DOCKET 50-255 - LICENSE DPR-20 - PALISADES PLANT -
IE INSPECTION REPORT 86032, ADDITIONAL INFORMATION

To RJFrigo, Palisades
From KAToner, Palisades *KAT*
Date March 19, 1987
Subject PALISADES PLANT - EEQ TRANSMITTER ERROR
ANALYSIS - IMPACT ON OPERATING PROCEDURES
CC RAFenech, Palisades
KEOsborne, Palisades

To KAToner
From RJFrigo *RJFrigo*
Date March 26, 1987
Subject PALISADES PLANT-
EEQ TRANSMITTER ERRORS
CC RAFenech
KEOsborne

INDICATION ERRORS RELATED TO DETERMINING SHUTDOWN COOLING ENTRY CONDITIONS

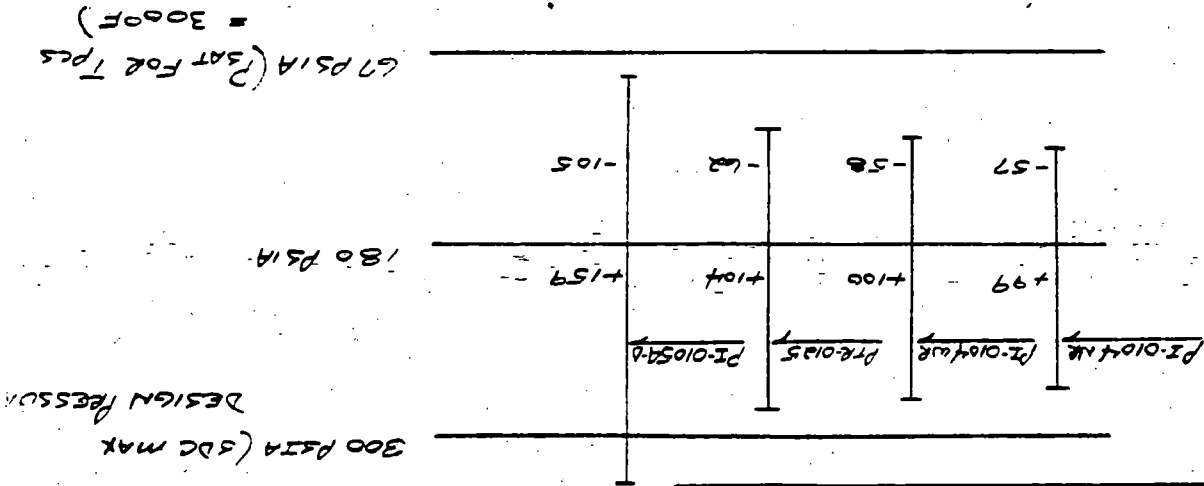
The strict use of PI-0104 and PTR-0125 is preferred over averaging all indications in this case, since the shifts in output owing to transmitter error are less for these instruments than that expected for the 0105 loops previously identified. Incorporating Recommendation 2 will ensure that neither the maximum SDCS design pressure or the minimum PCS pressure to ensure subcooling will be exceeded if PI-0104 and PTR-0125 are used (see attached sketch).

The 0105 loop errors result in peak-to-peak output shift variations of a magnitude which exceeds the pressure band between the overpressurization and subcooling limits regardless of what pressure within the band would be specified as signifying when the operator should open the valves. As a result, using the 0105 loops for this function would require averaging all readings; a practice which would likely reduce the overall inaccuracy of the reading but would not necessarily ensure that the actual PCS pressure would be within the acceptable bounds (see attached sketch).

- a) EOPs 4.0 (LOCA), 6.0 (ESDE), & 9.0 (Functional Recovery) have been modified to state "PCS pressure 270 psia (180 psia for degraded containment) OR less as indicated on PI-0104 OR PTR-0125" as a condition to go on shutdown cooling.
- b) No changes are warranted for the four S/G wide range instruments. The use of these instruments is in conjunction with other indications (Qualified CETs & PCS pressure trends) to determine if S/G heat removal capability is lost.
